Access Compliance Report

Public Rights-of-Way

(Curb Ramps)

Intersection ID: 9957	Main Street: ROSLYN_AV	Cross Street: S_SMALLWOOD_PL	Location: S
ADA ID: 18B6F71A2B4E	Ramp Type: BlendTrans1	Initial Pass/Fail: Fail	Overall Compliance: No
		Severity Score: 10

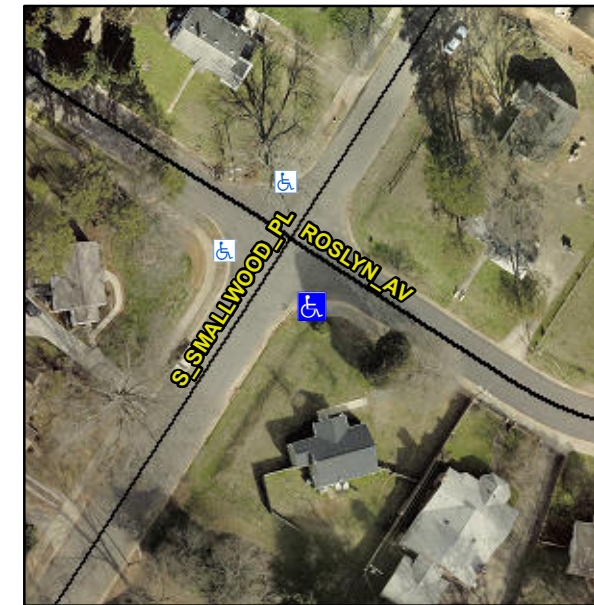
NO RT SW

Not Found, R304.5.1, R304.5.3

Remove & Replace Curb Ramp With Two New Directional Ramps or Equivalent.
